State of Ohio Environmental Protection Agency

**Re: Storm Water Inspection at Mount Gilead High and Middle Schools  
Permit #4GC02741\*AG**

This letter is written in follow-up to a construction storm water inspection by Katie Anderson and Rachelle Howe, of the Ohio EPA, at Mount Gilead High and Middle Schools located at 338 West Park Avenue in Morrow County on July 6, 2009. The purpose of the inspection was to ensure continued compliance with the General Storm Water Permit Associated with Construction Activities. During the inspection, we noted the following:

Figure 1

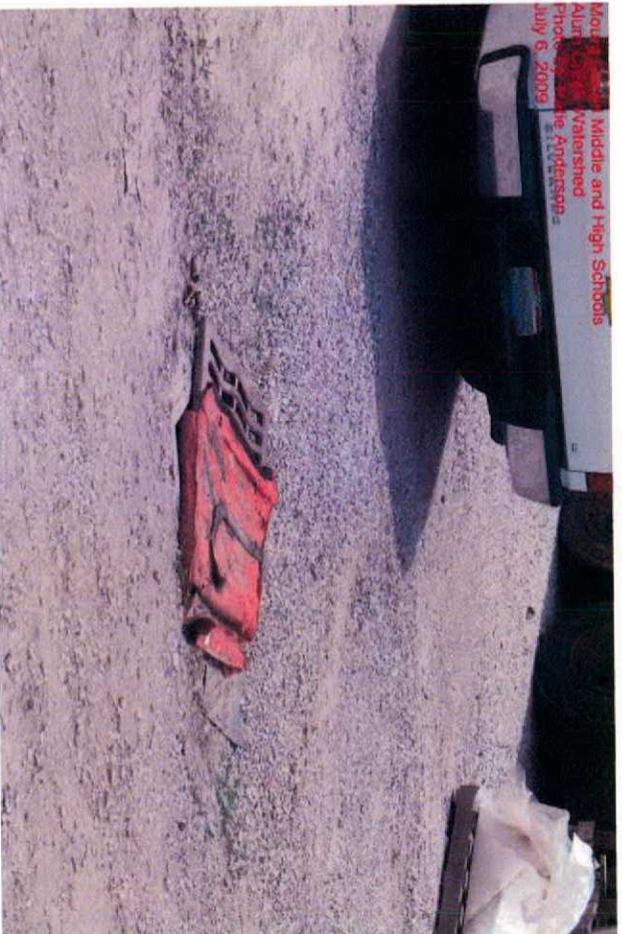
- An inlet appeared to be unprotected (see Photo Figure 1). This inlet requires protection or demonstrate an approvable alternative.
- The inlet protection on site requires maintenance to ensure proper functioning condition (see Photo Figure 2). This general permit states that all sediment controls will be inspected and maintained every seven days or within 24 hours of a precipitation event equal to or greater than 0.5 inches. A log of inspection must be maintained on site for the agency to review.
- Be aware the General Permit states that all barren areas which remain idle in excess of 21 days must be protected from erosion within seven days of the last earth disturbing activities. In addition, erosion protection must be implemented for all areas of final grade within seven (7) days.
